Wichita-Sedgwick County Metropolitan Area Planning Department

CASE NUMBER: VAC2007-00040: Request to vacate a portion of a platted reserve and the restriction of uses.

REASON FOR REQUEST: Revert to street right-of-way (ROW)

BERKELEY SQUARE PARKWAY: Pavement Dimensioning Plan

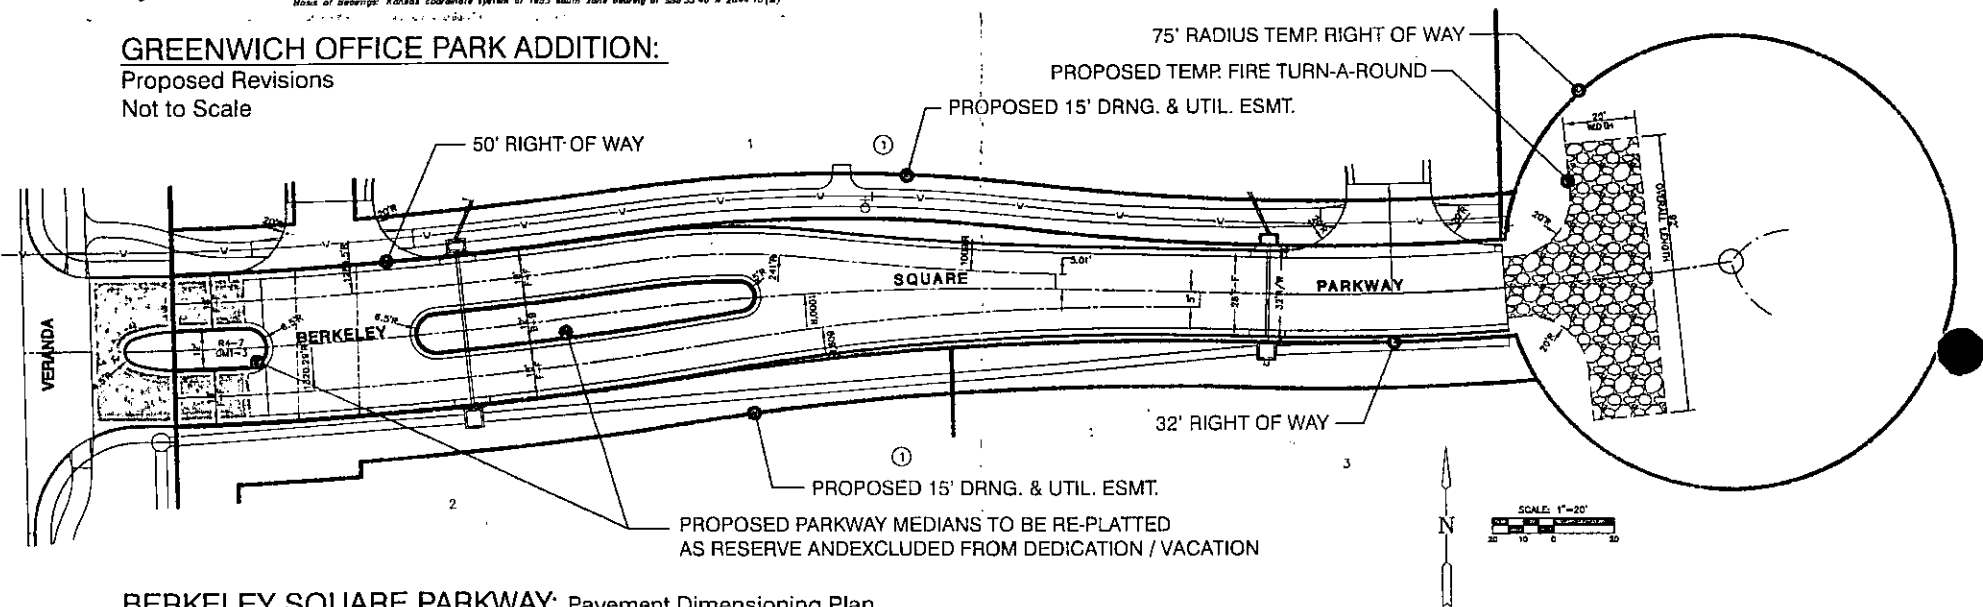
- (1) The reserve/proposed public ROW's width will remain the same as it is platted on the Greenwich Office Park Addition, but it will have 29-feet of paving, back to back. Provide a guarantee for the paving, per the standards for materials and depth for a commercial road. The guarantee must be provided prior to the case going to WCC for final action.

- (2) The west side of the reserve/proposed public ROW is the entrance/exit point. Provide Fire with 20-feet of paved access ingress (entrance) and 24-feet of paved egress (exit) from the reserve/proposed public ROW onto the public ROW it intersects on its west side: SUB2007-36, The Waterfront Residential Addition, approved by WCC 11-06-2007: the 'Veranda' intersection on the site plan. Provide a 24-foot radius on the ingress/egress onto of the proposed public ROW, 'Veranda'. If the applicant provides 20-foot of ingress and 20-feet of egress at this point, the radius of the median strip in the proposed public ROW must be 24-feet and must have a roll over curb. The city will not be responsible for the maintenance and repair of the median strip and any uses located on it. Provide Fire with a survey of the 'Veranda' and 13th ROWs where they are adjacent to the subject site, showing all proposed and existing median strips, curb cuts, turn in radius, etc.

- (3) The east side of the reserve/proposed public ROW is a dead-end. Provide Fire with a 96-foot diameter cul-de-sac, or a 120-foot alternative hammerhead, or a 120-foot hammerhead, at the east end of the reserve/proposed public ROW; turn around. The turn around may be dedicated temporary, contingent on the extension of the reserve/proposed public ROW to the east. For the first year after the vacation request's approval by the WCC, a cul-de-sac/hammerhead will have an approved gravel/surface, per Fire's recommendation; provide a guarantee for the approved gravel surface. Provide a guarantee for the paving of the permanent cul-de-sac, per commercial standards for design, materials and depth, to be used/in effect after one-year of the vacation requests approval by the WCC. The guarantee must be provided prior to the case going to WCC for final action.

- (4) Dedicate 15-foot street, drainage and utility easements, to run parallel to the north and south sides of the reserve/proposed public ROW. Provide to staff prior to the request going to the WCC for final action.
